**IMPERIAL ROAD DESIGN MANUAL**  
**REVISIONS January, 2012**

**FIGURE 2E-8.2 DEPICTING TEMPORARY CONSTRUCTION EASEMENT FOR ENTRANCES**

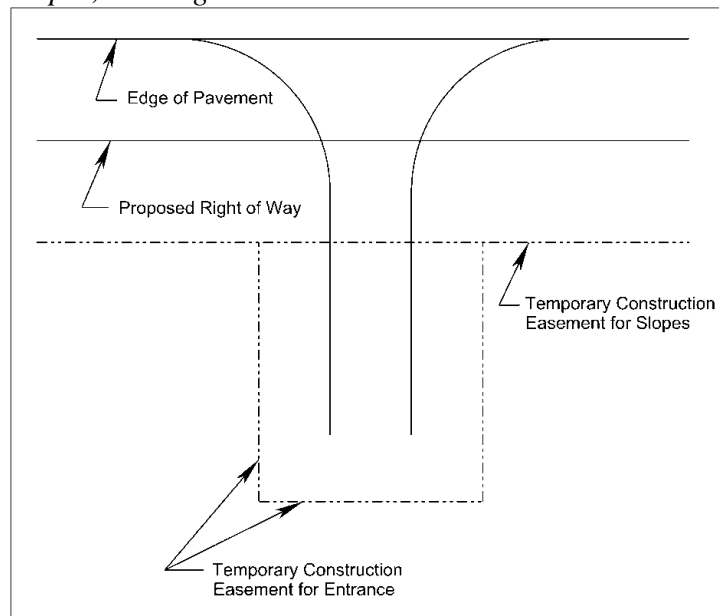
- Page 2E-21 – Revised language in the first sentence of this page from; “Recommended by the Field Inspection Report, the Residency Administrator or the city/county...” to; “*Recommended by the Field Inspection Report or the city/county...*”
- Page 2E-39 & 40 – Added the following language;  
***Temporary Construction Easements***

### ***Requirements for Temporary Construction Easements (TCE) around Entrances***

*All TCE shall be labeled on the plans for there specific intended use such as: cut/fill slopes, drainage, detours and entrances). For example: (Prop. Temporary Construction Easement (TCE) for Entrance).*

*ALL TCE for Entrances shall be summarized separately on the Right of Way Data Sheet from all other TCE such as cut/fill slopes, drainage and detours. The Right of Way Data Sheet has been revised to add a column for Temporary (Entrances) and is in the CADD Cell Library.*

*All TCE for Entrances shall be computed for each parcel (if applicable) and summarized on the Plat in the Areas of Easements Table. See VDOT’s Survey Manual, Chapter 12, Figure 12-D for a Sample Right of Way Acquisition Plat.*

Whenever the proposed entrance replacement construction is not minor, as defined herein, the plans shall include Proposed Temporary Construction Easement (TCE) limits to facilitate the proposed work. Temporary Construction Easements for Entrance shall be clearly labeled for that purpose (Prop. Temporary Construction Easement (TCE) for Entrance) and will have a different duration from other temporary construction easements for other purposes such as cut/fill slopes, drainage and detours.

- Page 2E-46 – Added the following information on “Surplus Right of Way”;  
***DETERMINING SURPLUS RIGHT OF WAY***

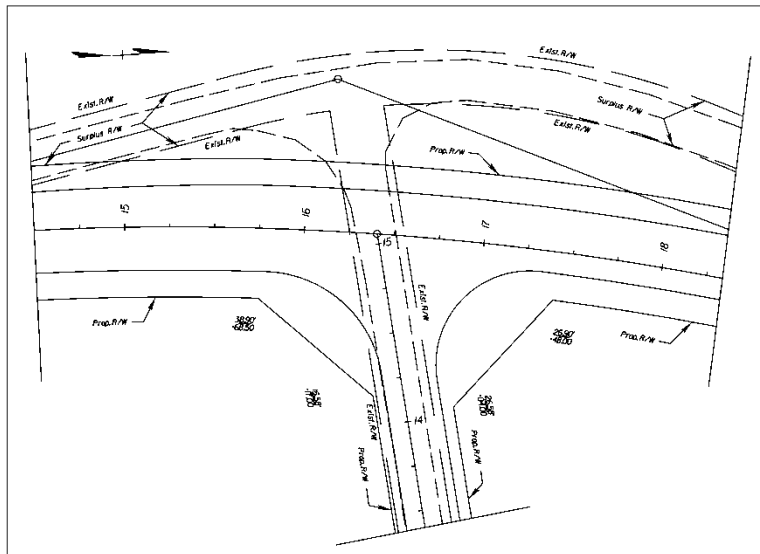
*Prior to presenting the plans for public hearing the designer shall designate (with the Residencies concurrence) all areas on the project that are currently existing right of way that can be designated “Surplus Right of Way”. By labeling the surplus in this manner, the surplus property has been established and will be included in the Right of Way Division’s “Residue Parcels Inventory” for disposal purposes.*
